# Access Compliance Report

## Public Rights-of-Way

### (Curb Ramps)

Intersection ID: 42665	Main Street: WALLACE_AV	Cross Street: WALLACE_GLEN_DR	Location: S
ADA ID: 016525D72794	Ramp Type: Perp	Initial Pass/Fail: Fail	Overall Compliance: No
Severity Score: 13.75			
Codes/Mitigation Info/Possible Solution		Field Measurements/Component Compliance

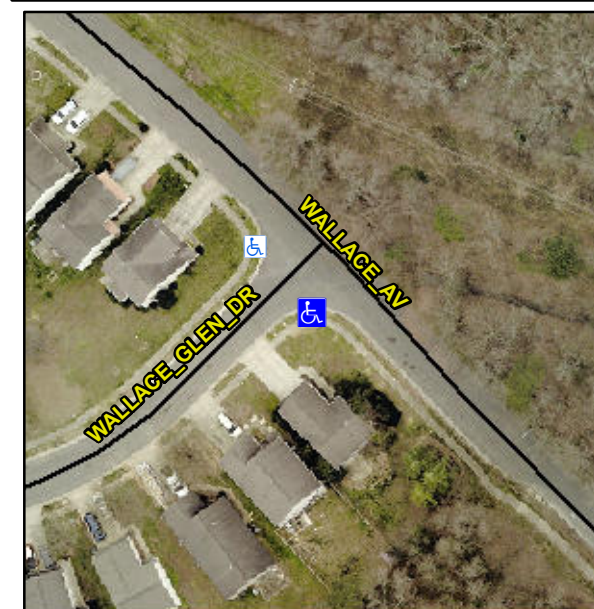
**Not Found, R304.2.2, R304.5.3**

Compliance	Description	Data	Compliance	Description	Data
N/A	Ramp Length (in)	49.0	No	Ramp Slope (%)	8.4
Yes	Ramp Width (in)	48.0	No	Ramp XSlope (%)	3.0
N/A	Flare Type LT	N/A	N/A	Flare Type RT	N/A
N/A	Flare Slope LT (%)	N/A	N/A	Flare Slope RT (%)	N/A
N/A	Flare Traversable LT?	N/A	N/A	Flare Traversable RT?	N/A
N/A	Landing Length (in)	N/A	N/A	DWS Provided?	N/A
N/A	Landing Width (in)	N/A	N/A	DWS Contrast?	N/A
N/A	Landing Slope (%)	N/A	N/A	DWS Length (in)	N/A
N/A	Landing X Slope (%)	N/A	N/A	DWS Full Width?	N/A
N/A	Landing Curb? (Y/N)	N/A	N/A	DWS Offset (in)	N/A
N/A	Shared Landing?	N/A			
N/A	Gutter Ponding?	N/A	N/A	Gutter Slope (%)	N/A
N/A	Gutter Lip Ht (in)	N/A	N/A	Gutter X Slope (%)	N/A
N/A	Painted X Walk1?	No	N/A	Painted X Walk2?	N/A
	X Walk 1 Direction	To NW		X Walk 2 Direction	N/A
N/A	X Walk 1 Width (in)	N/A	N/A	X Walk 2 Width (in)	N/A
	X Walk 1 Slope (%)	0.7		X Walk 2 Slope (%)	N/A
	X Walk 1 X Slope (%)	2.5		X Walk 2 X Slope (%)	N/A

**Remove & Replace Entire Ramp.**
